**NOTICE OF REGULAR MEETING  
KERSEY PLANNING AND ZONING COMMISSION  
KERSEY MUNICIPAL BUILDING  
446 1<sup>st</sup> Street, Kersey, CO  
TUESDAY, FEBRUARY 6, 2024  
6:00 P.M.**

**Subject:** Puryear Change of Zone Request for D - Industrial Zoning

**Subject:** Highway 34 Transportation Center Lot 4 Site Plan Application

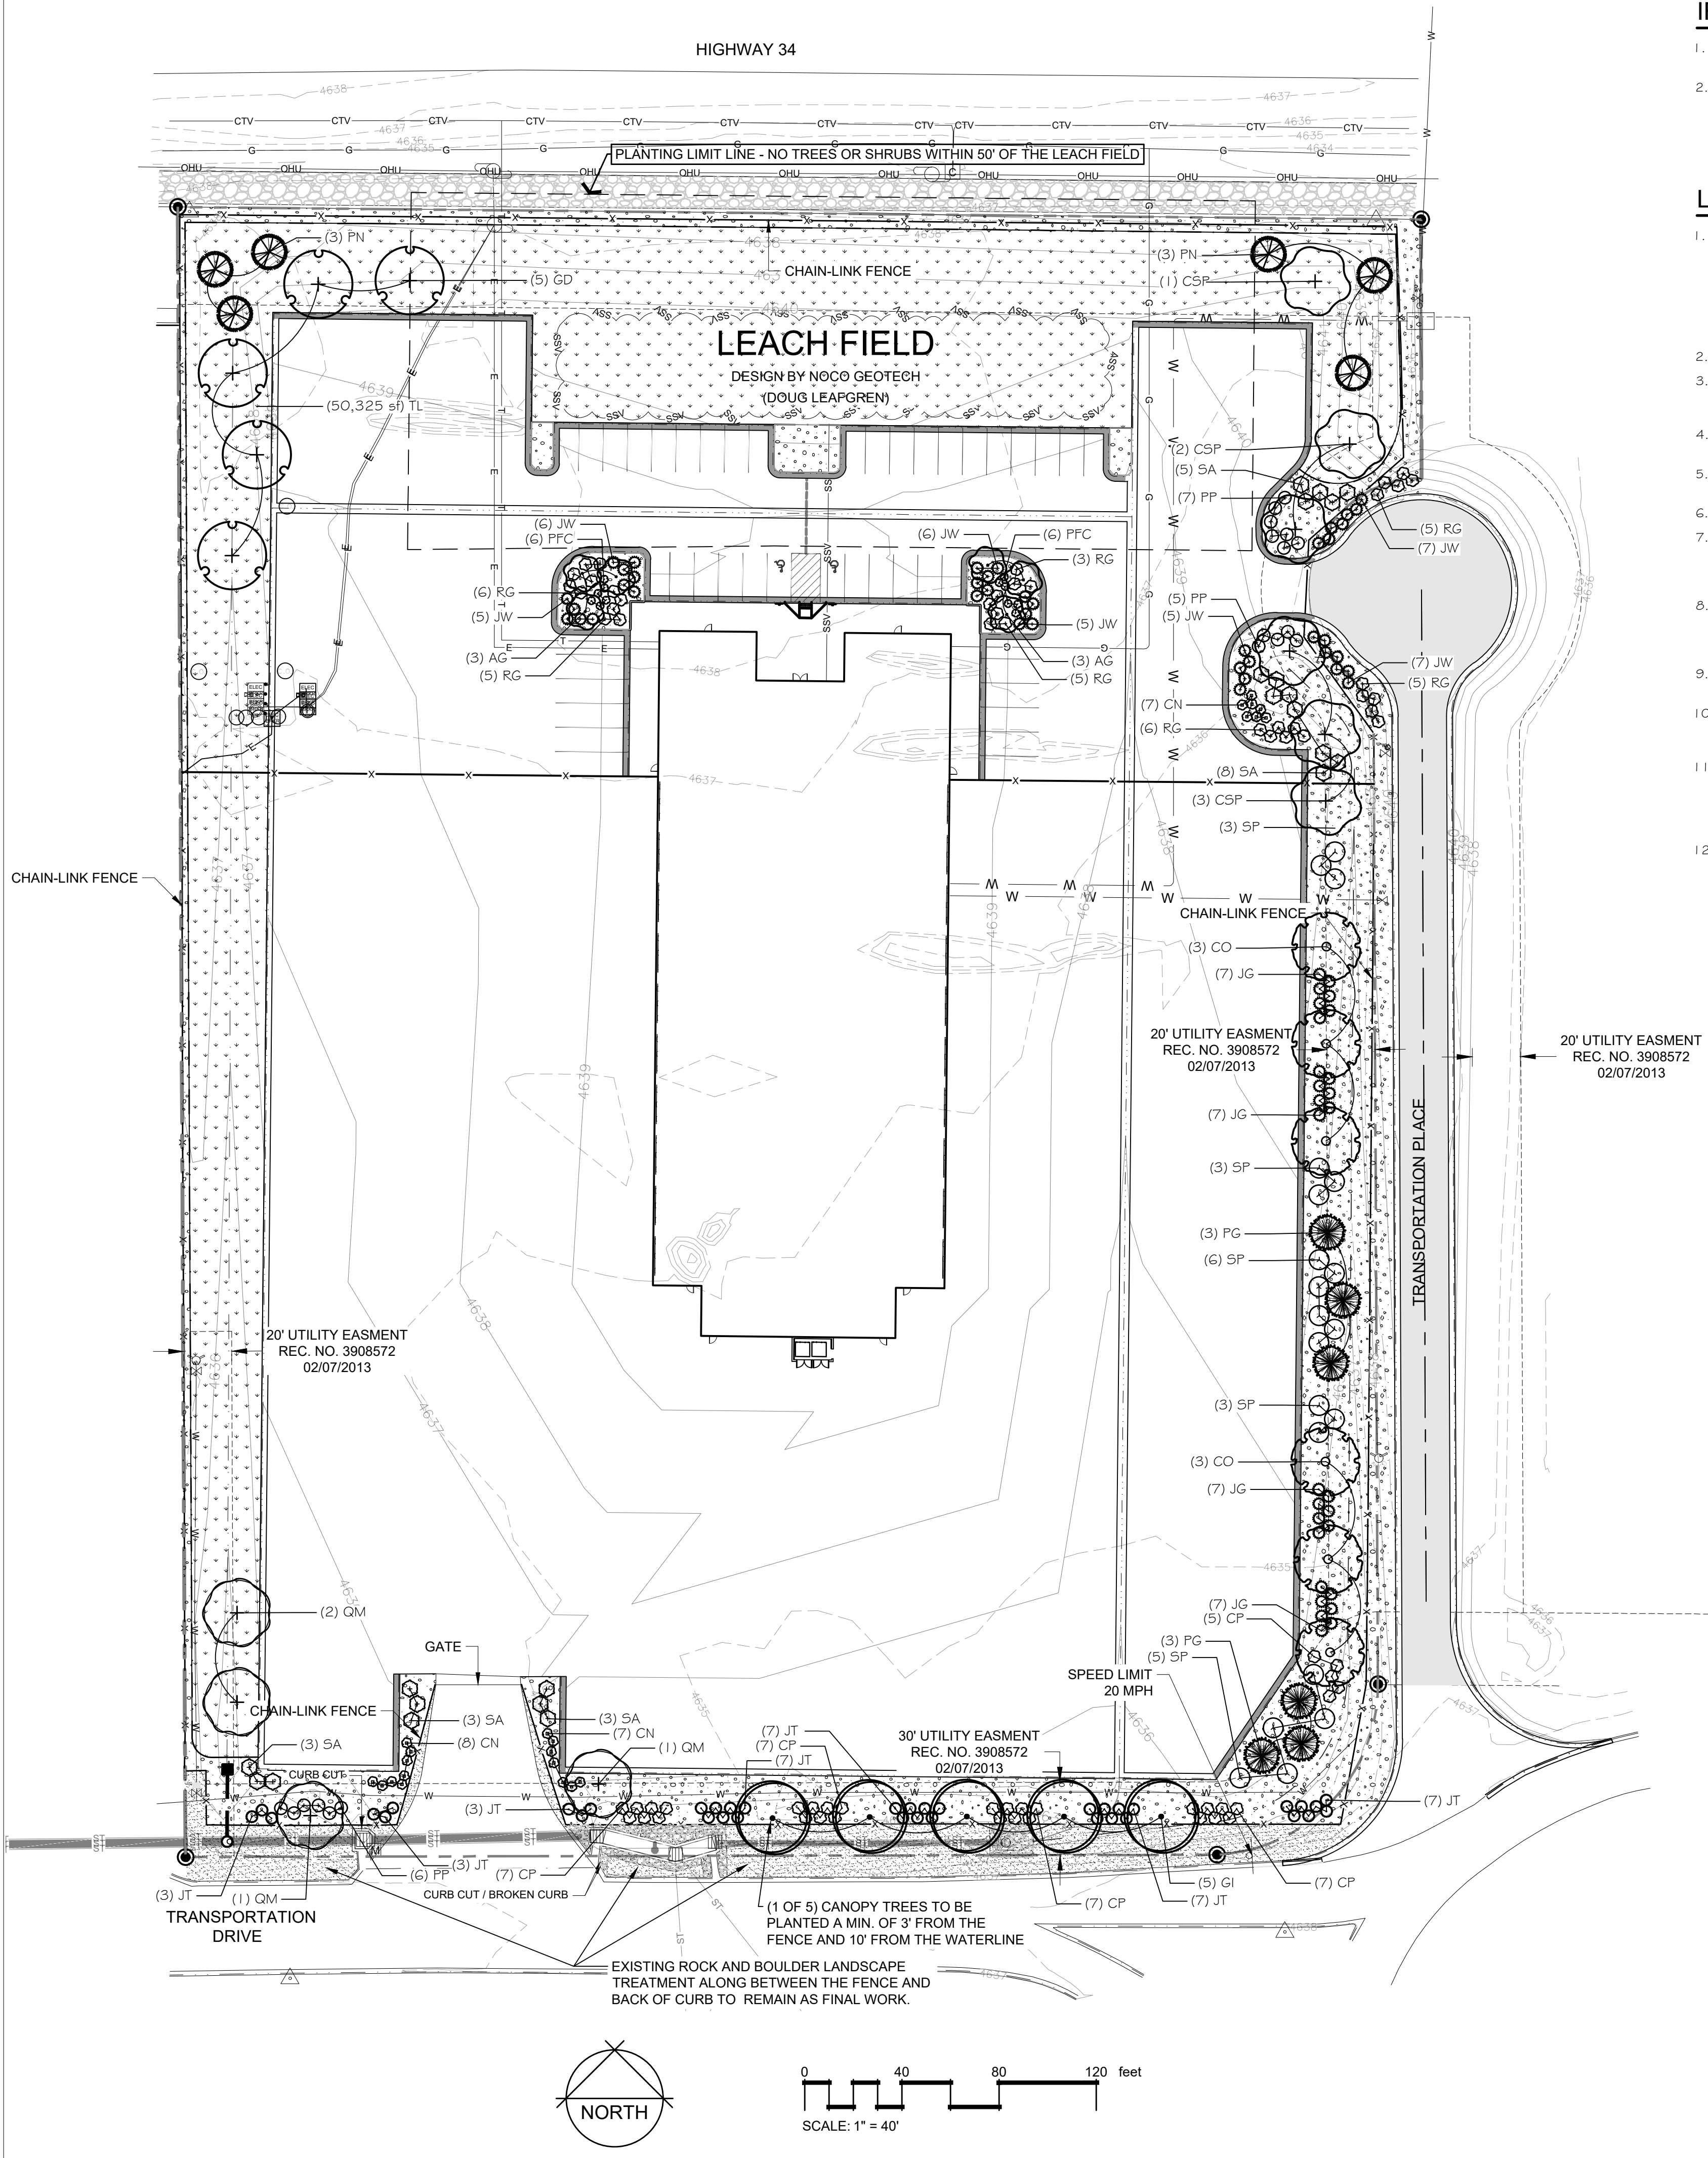
- The proposed landscaping generally meets the intent of the Code. The applicant will submit a final landscape plan that complies with Town requirements prior recording the site plan or submit a waiver for the Town Board's approval.

SHEET DESCRIPTION  
SITE PLAN - PHOTOMETRIC

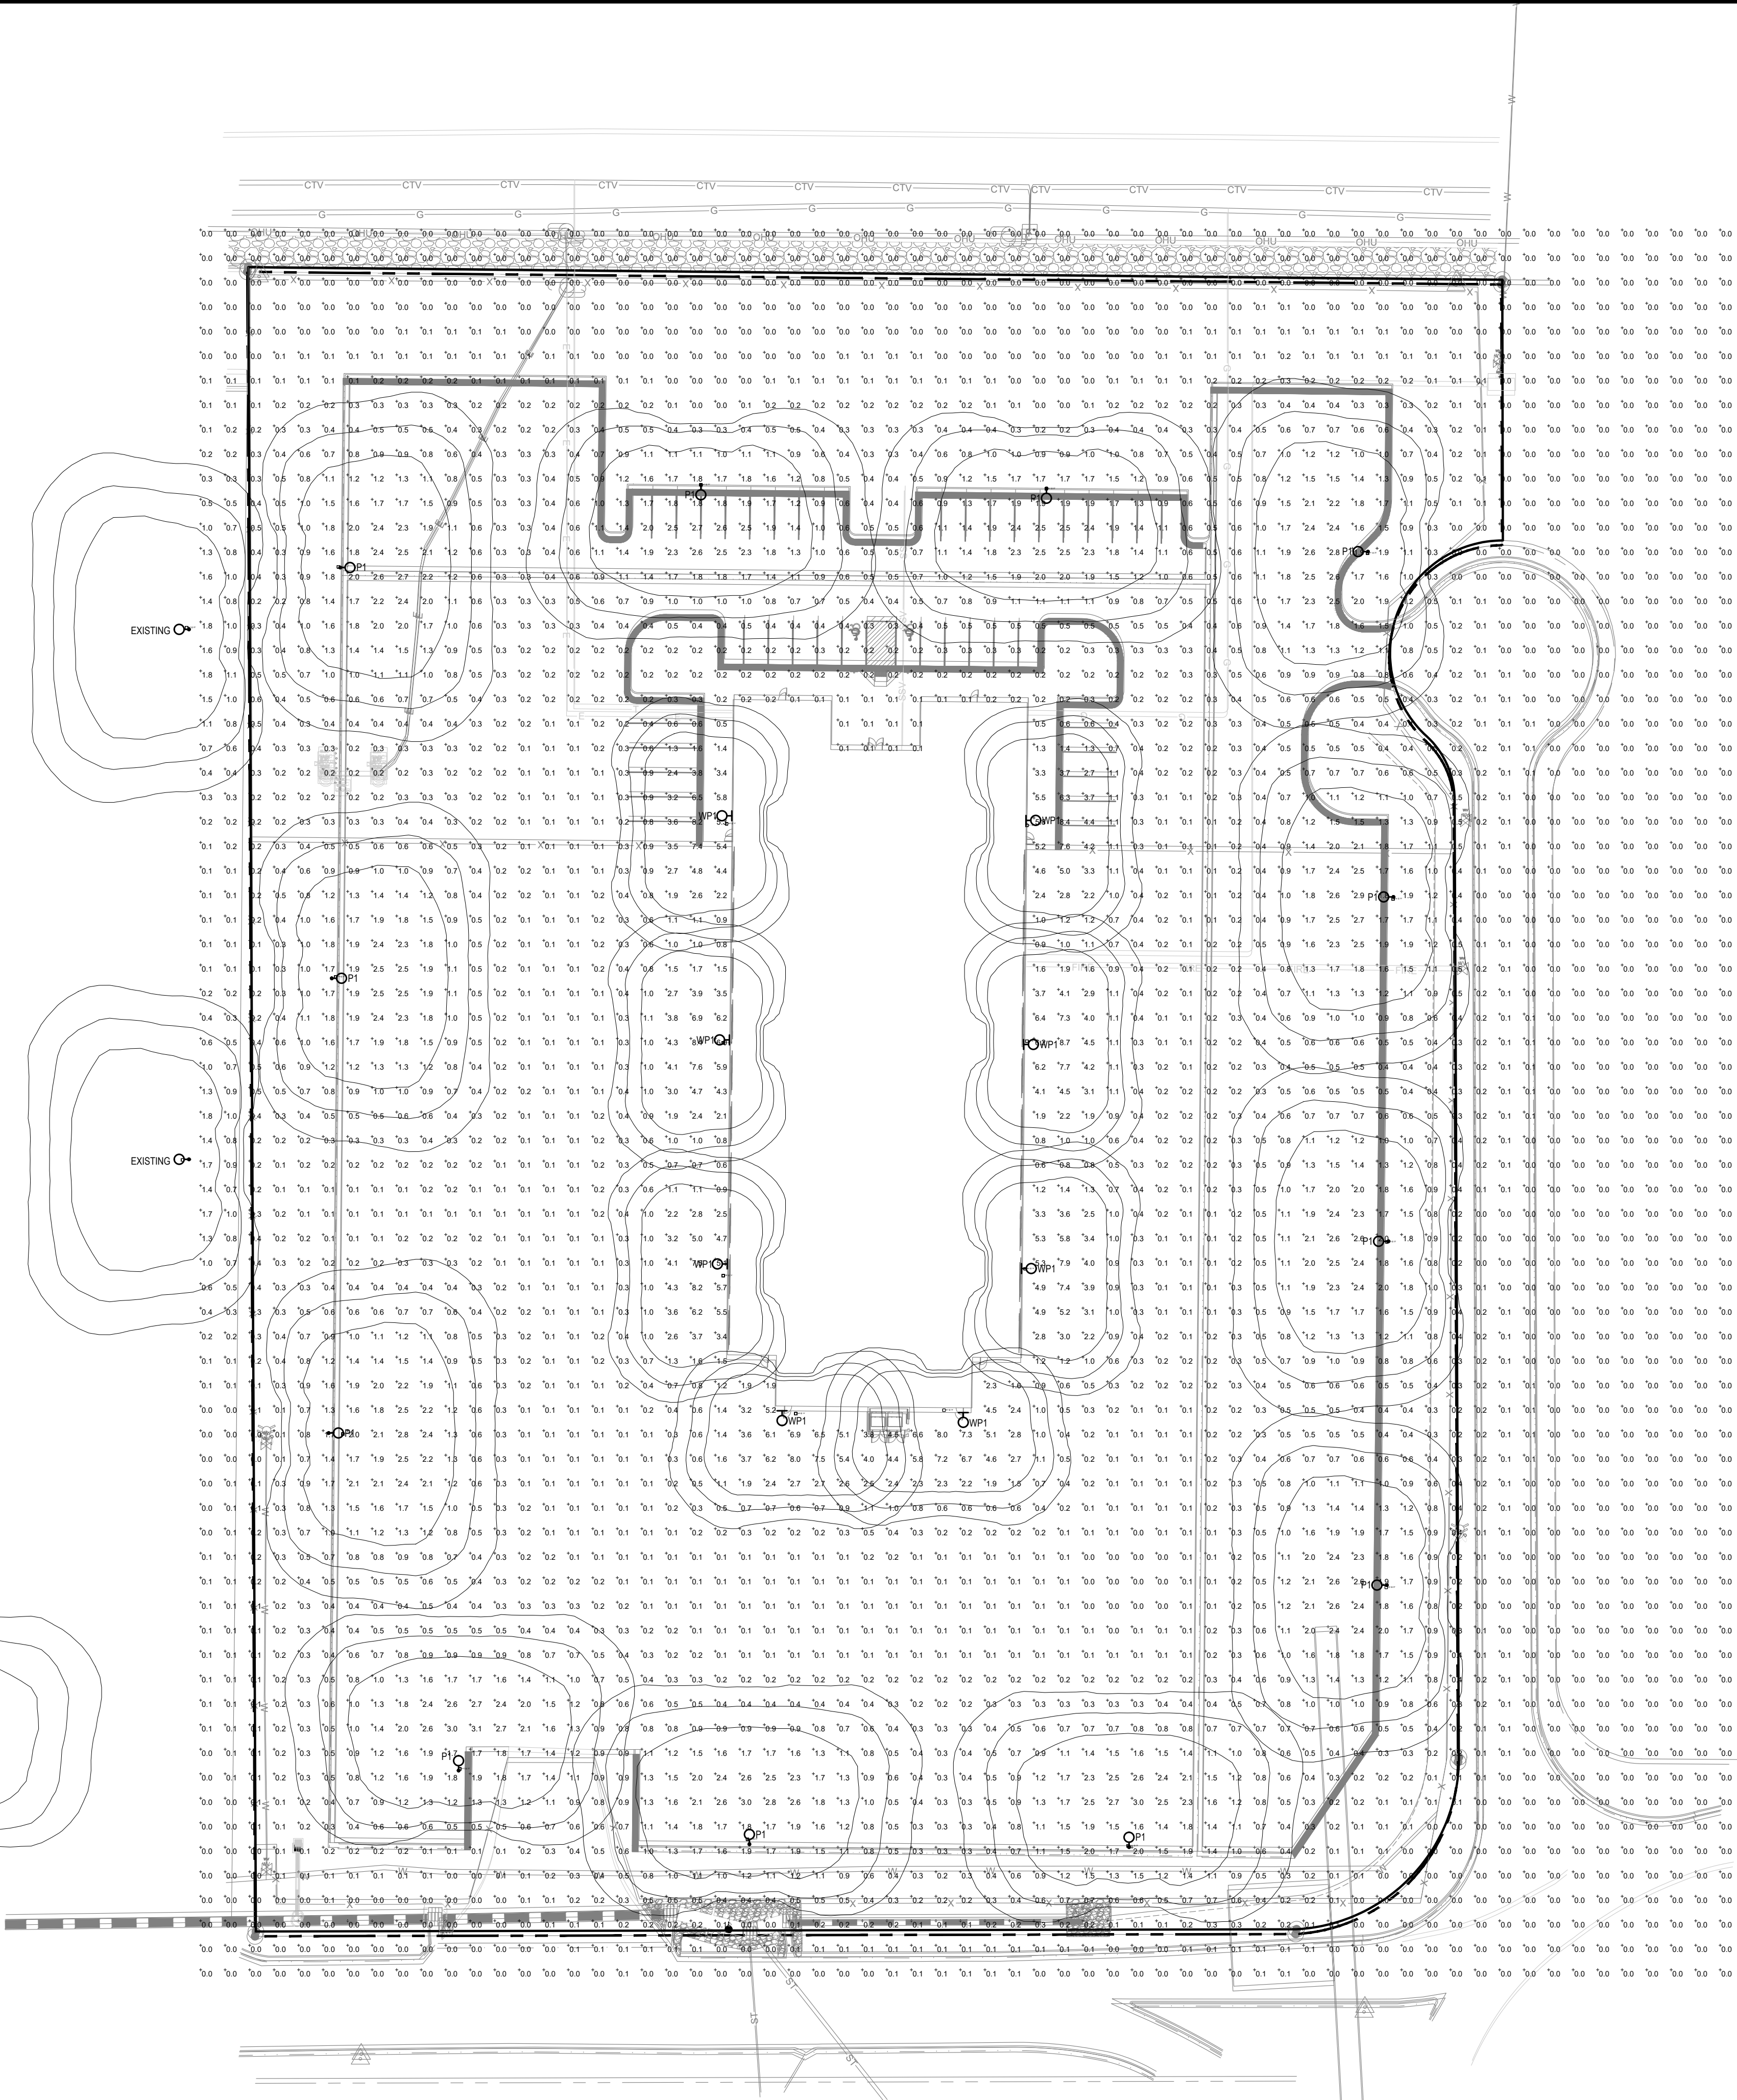
- All proposed lighting is dark sky compliant, and parking utilizes full cutoff fixtures. The applicant submitted a photometric plan that demonstrates the light will be contained on the property. Lights are arranged as to reflect the light away from nearby residential properties, and away from the vision of passing motorists.
